Access Compliance Report

Public Rights-of-Way

(Curb Ramps)

Intersection ID: 31392	Main Street: COVINGTONWOOD_DR	Cross Street: POINTER_RIDGE_DR	Location: W
ADA ID: 193638A862E6	Ramp Type: BlendTrans1	Initial Pass/Fail: Fail	Overall Compliance: No
Severity Score: 8.75			
Codes/Mitigation Info/Possible Solution		Field Measurements/Component Compliance

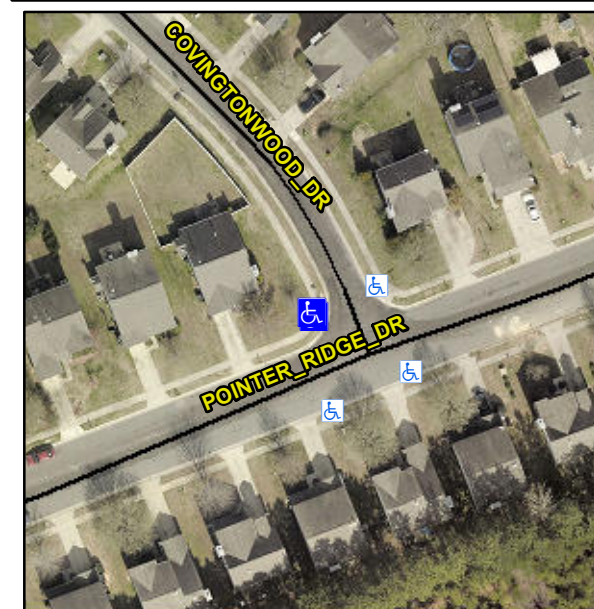
R304.5.1

Compliance	Description	Data	Compliance	Description	Data
N/A	Ramp Length (in)	48.0	Yes	BlendTrans Slope (%)	2.8
No	Ramp Width (in)	40.0	Yes	BlendTrans XSlope (%)	0.6
N/A	Flare Type LT	N/A	N/A	Flare Type RT	N/A
N/A	Flare Slope LT (%)	N/A	N/A	Flare Slope RT (%)	N/A
N/A	Flare Traversable LT?	N/A	N/A	Flare Traversable RT?	N/A
N/A	Landing Length (in)	N/A	N/A	DWS Provided?	N/A
N/A	Landing Width (in)	N/A	N/A	DWS Contrast?	N/A
N/A	Landing Slope (%)	N/A	N/A	DWS Length (in)	N/A
N/A	Landing X Slope (%)	N/A	N/A	DWS Full Width?	N/A
N/A	Landing Curb? (Y/N)	N/A	N/A	DWS Offset (in)	N/A
N/A	Shared Landing?	N/A			
N/A	Gutter Ponding?	N/A	N/A	Gutter Slope (%)	N/A
N/A	Gutter Lip Ht (in)	N/A	N/A	Gutter X Slope (%)	N/A
N/A	Painted X Walk1?	No	N/A	Painted X Walk2?	No
	X Walk 1 Direction	To SE		X Walk 2 Direction	To NE
	X Walk 1 Width (in)	N/A		X Walk 2 Width (in)	N/A
	X Walk 1 Slope (%)	4.6		X Walk 2 Slope (%)	2.9
	X Walk 1 X Slope (%)	0.0		X Walk 2 X Slope (%)	1.5

Remove & Replace Curb Ramp With Two New Directional Ramps or Equivalent.
